Subject: Duke Energy Carolinas, LLC  
William States Lee III Nuclear Station – Docket Nos. 52-018 and 52-019  
AP1000 Combined License Application for the  
William States Lee III Nuclear Station Units 1 and 2  
Supplemental Response to Request for Additional Information  
Ltr# WLG2012.04-08

**Lee Nuclear Station Response to Request for Additional Information (RAI)**

**Reference NRC RAI Number: ER RAI 190 Supplement, Site Layout and Plant Description**

**Reference NRC RAI Number: ER RAI 210 Supplement, Ecology - Aquatic**

**Updated ER Figure 5.3-3,  
Make-Up Pond A Intake Structure  
Sheets 1 through 5 of 5**

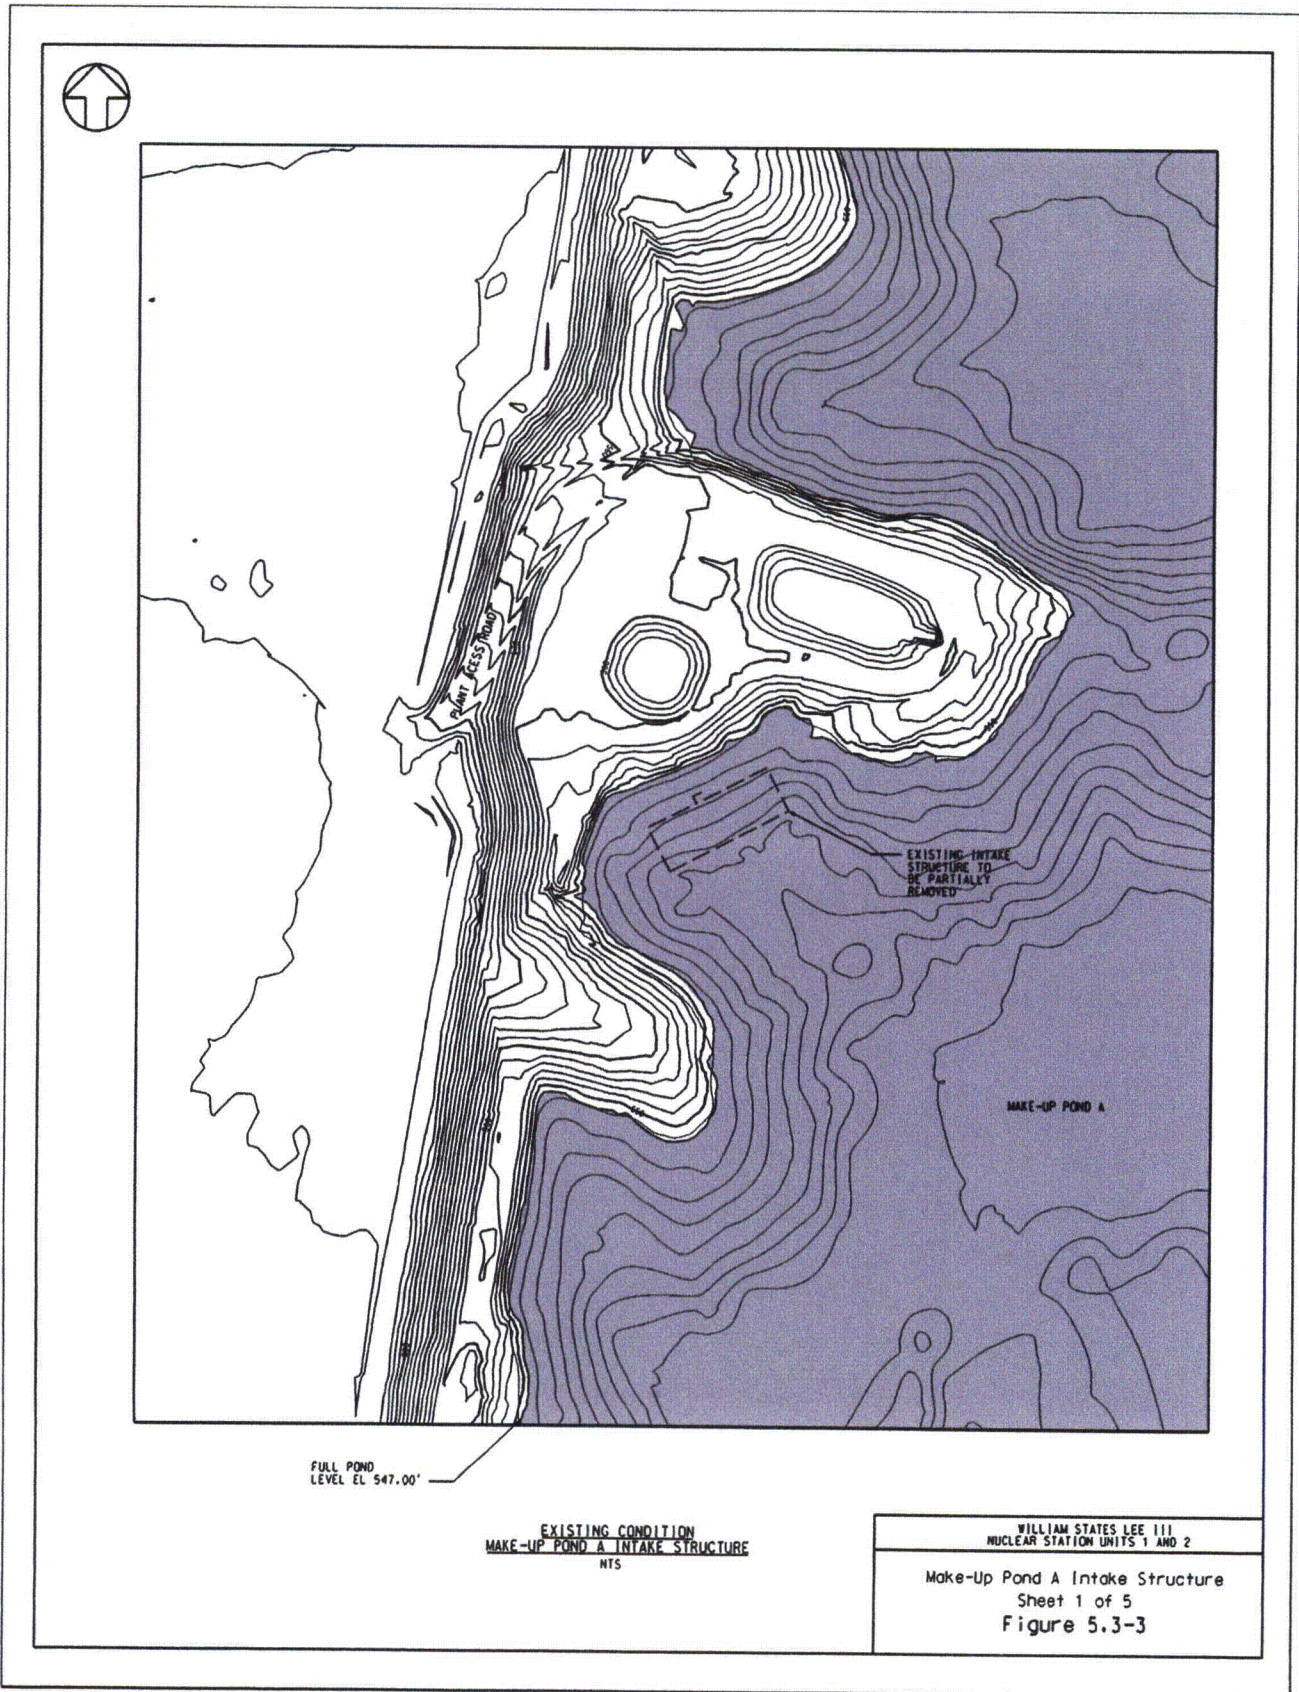
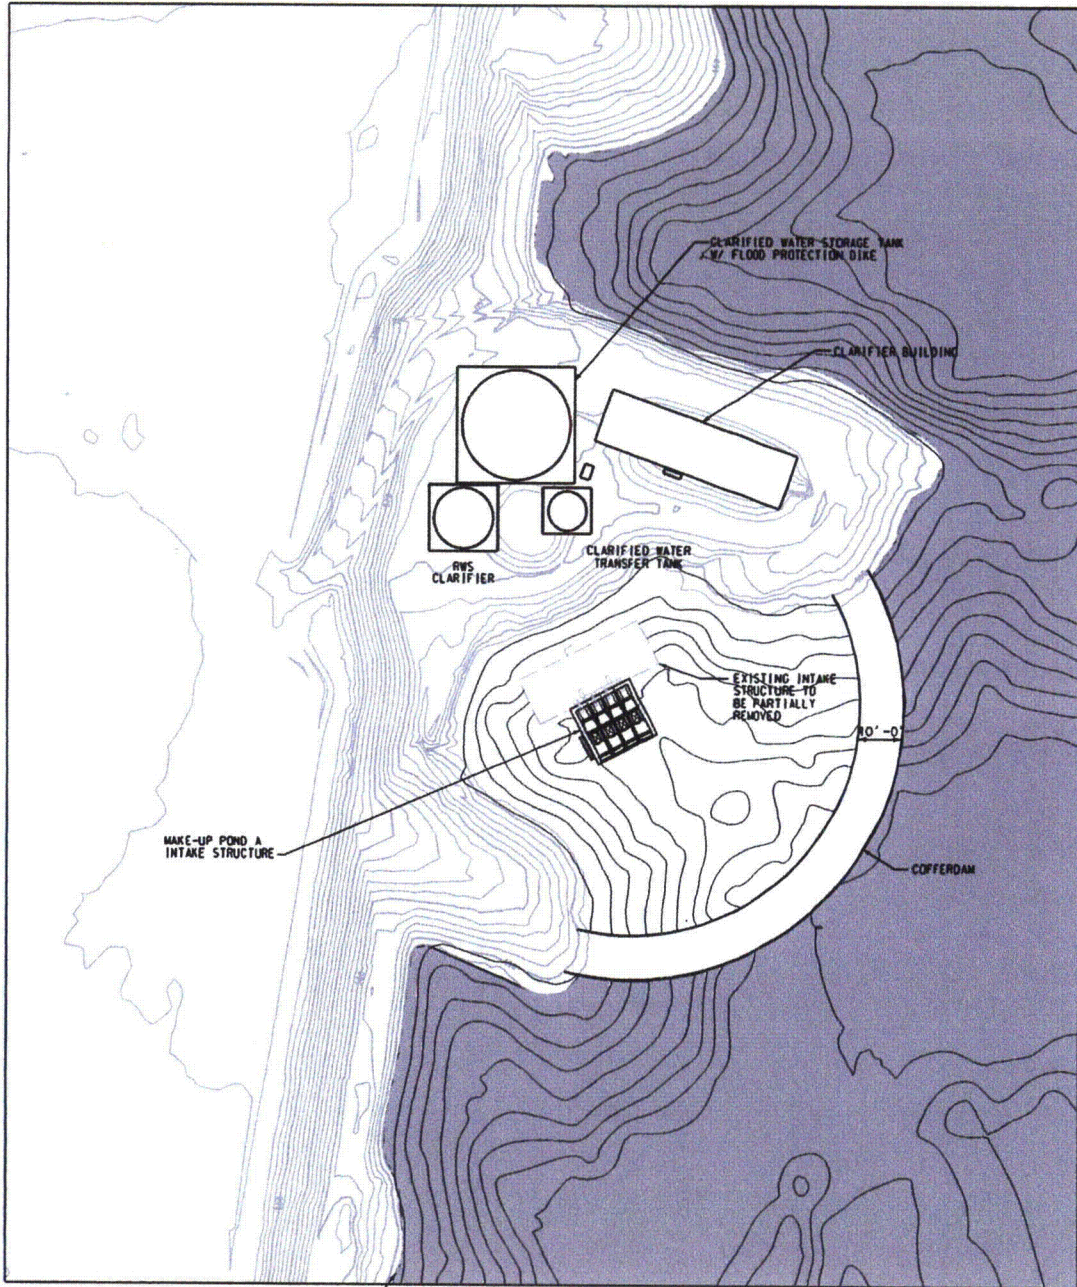
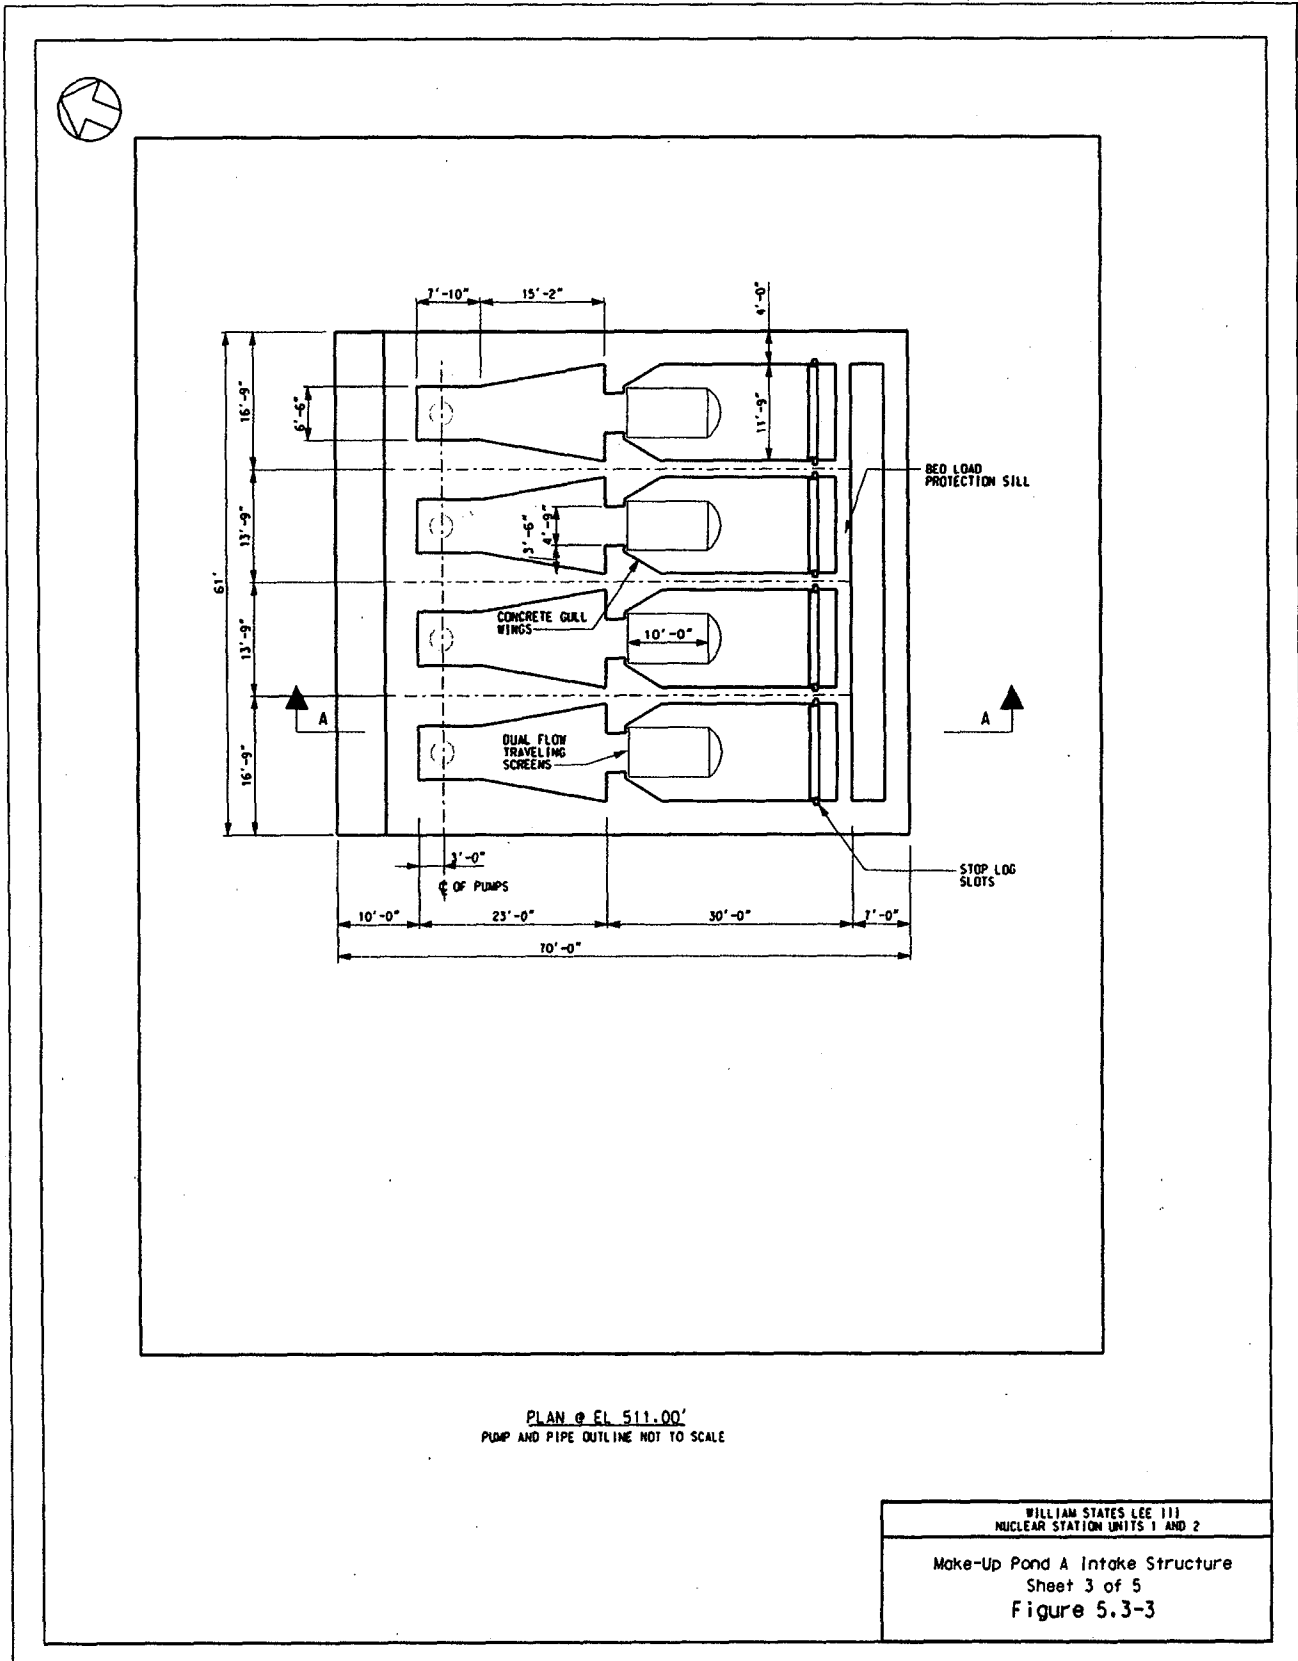
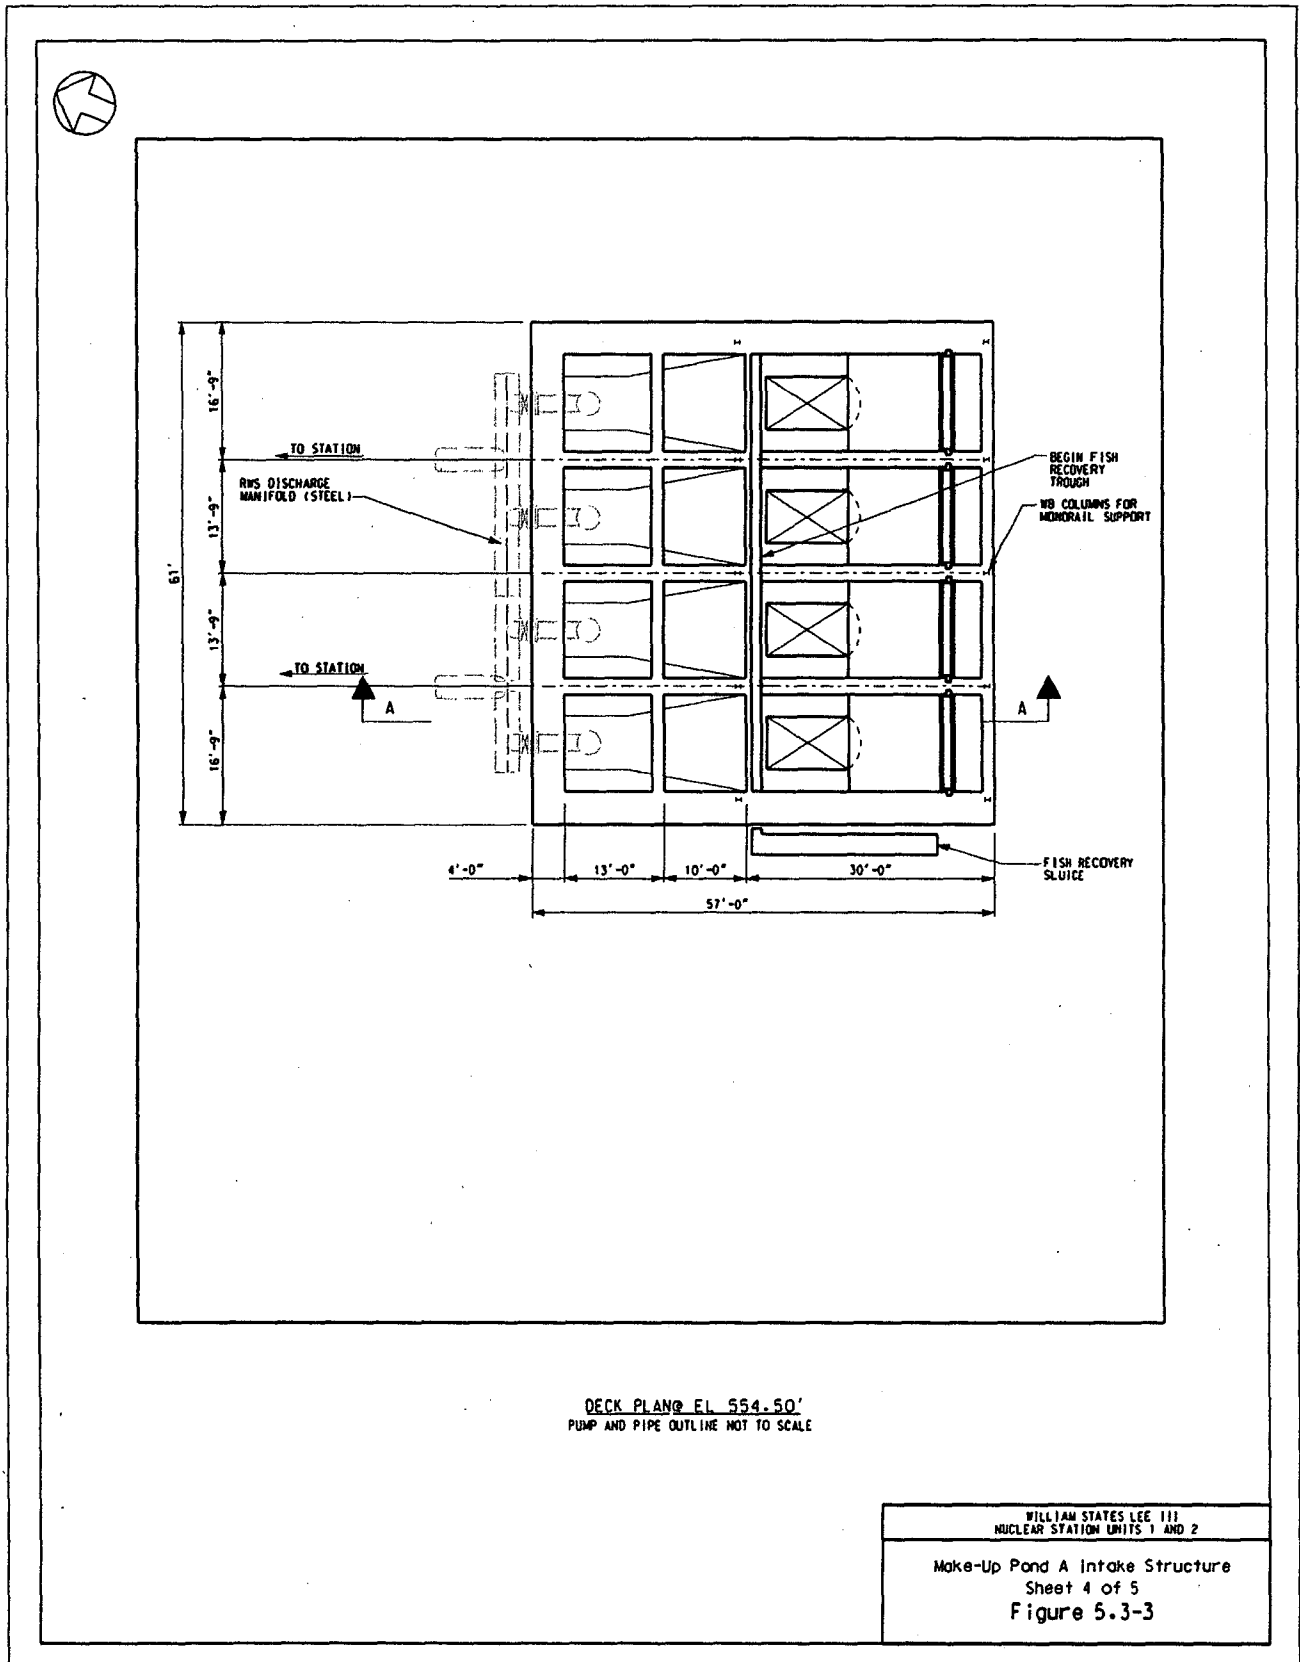
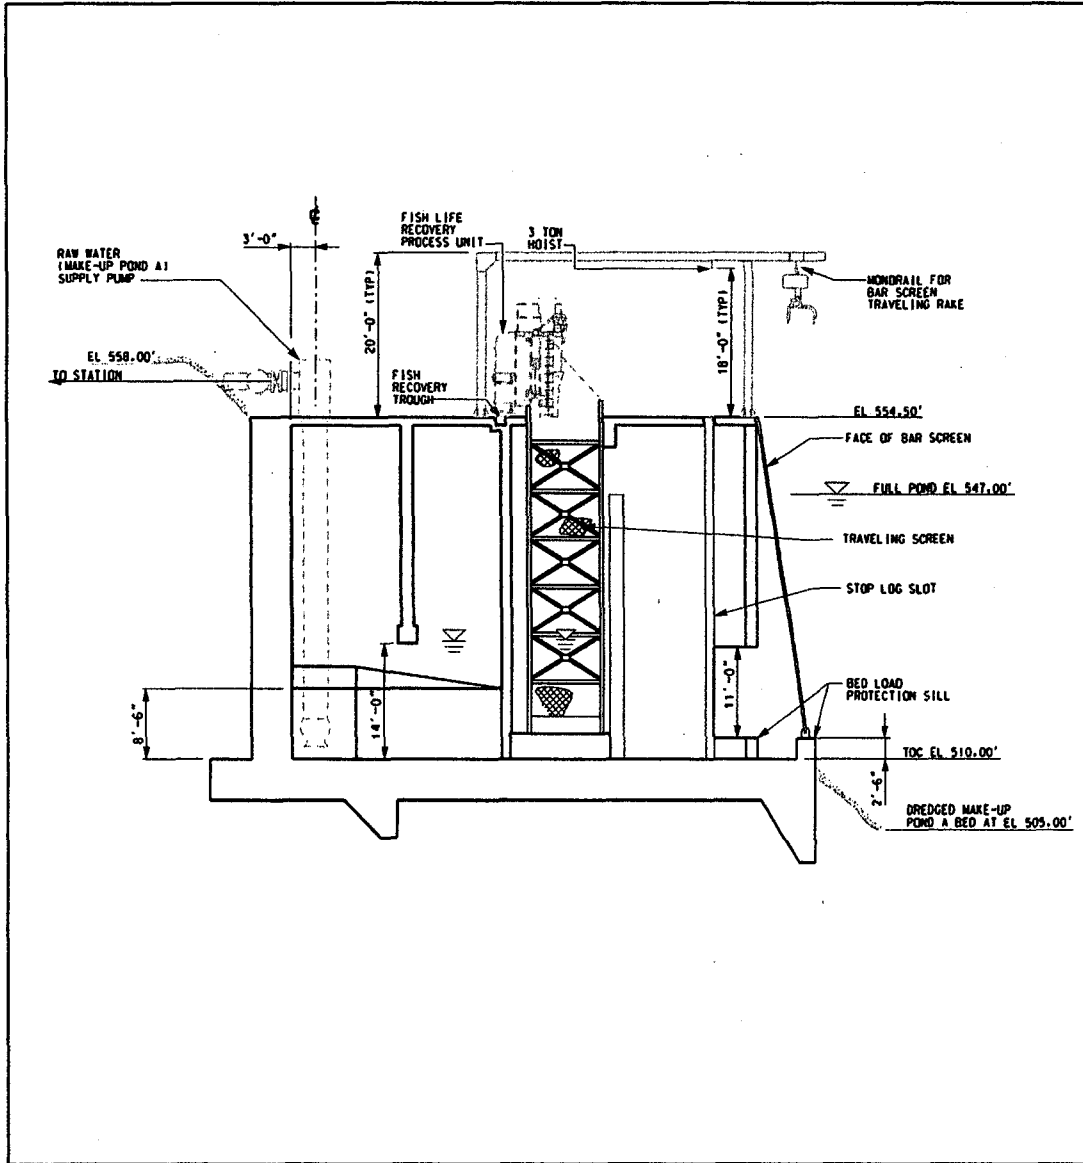
Provide bathymetric maps of Ponds A, B, and C that show clearly labeled contour lines with the locations of the intake screen and supporting structures superimposed. Provide plan and section views of each intake structure. For clarity and legibility, print the maps in black and white. Describe what is known about the options for wedge wire slot sizes for the traveling screens, particularly if an estimate or range of potential slot sizes is known. Provide information about the height the Pond B and C drum screens will be elevated above the substrate. Also, describe the potential cleaning methods for the Ponds A, B, and C intake screens. Indicate in the response when and how through-screen velocity calculations will be provided to the NRC (e.g., through submittal of a copy of the National Pollution Discharge Elimination System permit application).

The number of pumps/pump bays in the Make-Up Pond A Intake Structure have changed from six (6) to four (4) as reflected on ER Figure 5.3-3 (Attachment 210S-01). The number of pumps have been changed from three pumps per unit (six total) to two pumps per unit (four total) to more closely align the sizing of these pumps with the required make-up flow for the Circulating Water System (CWS) under anticipated normal operation at four cycles of concentration. Additional details of the Dual Flow Traveling Screens and concrete walls have been added to the plan and section views of the Make-Up Pond A Intake Structure as reflected on ER Figure 5.3-3 (Attachment 210S-01). Updated calculations have confirmed that through-screen velocity on these Dual Flow Traveling Screens will be less than 0.5 ft/sec. A portion of the Make-Up Pond A Intake Structure from the previous Cherokee Nuclear Station construction will be left in place (existing structure to be partially removed) to support access to the Make-Up Pond A Intake Structure for Lee Nuclear Station which is located deeper in Make-Up Pond A as reflected on ER Figure 5.3-3 (Attachment 210S-01).
